Scott Horsley Water Resources Consultant

May 2, 2024

RE: Cascade Wayland -113, 115, 117, and 119 Boston Post Road, Wayland, MA

Figure 1 – Site Plan Showing Wastewater Discharge Area and Groundwater Flow Directions Towards Pine Brook

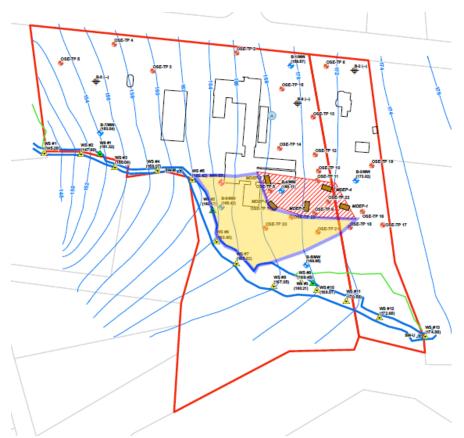
1. The Hydrogeologic Report includes a water table map that indicates a westerly groundwater flow direction from the "wastewater discharge area" towards and into Pine Brook. Pine Brook is a "gaining stream" meaning that it derives its baseflow from surrounding groundwater that discharges into it. The proposed wastewater

discharge to groundwater will contribute directly to this baseflow (see figures 1 and 2).

Figure 1 - Coldwater Fishery (Source: Massachusetts Division of Fisheries and Wildllife)

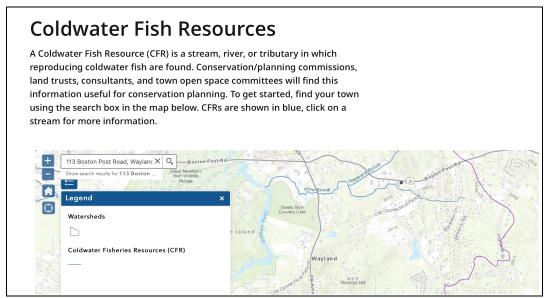
- 7. Pine Brook is a coldwater fishery and is utilized for both primary and secondary recreational contact. YMCA Camp Chickami is located on Pine Brook and directly downstream of the proposed development. This facility is reported to utilize the brook and attached ponds as a play area for children, who would be put at risk of harmful algal blooms (HABs) caused by excessive nitrogen and phosphorus discharges.
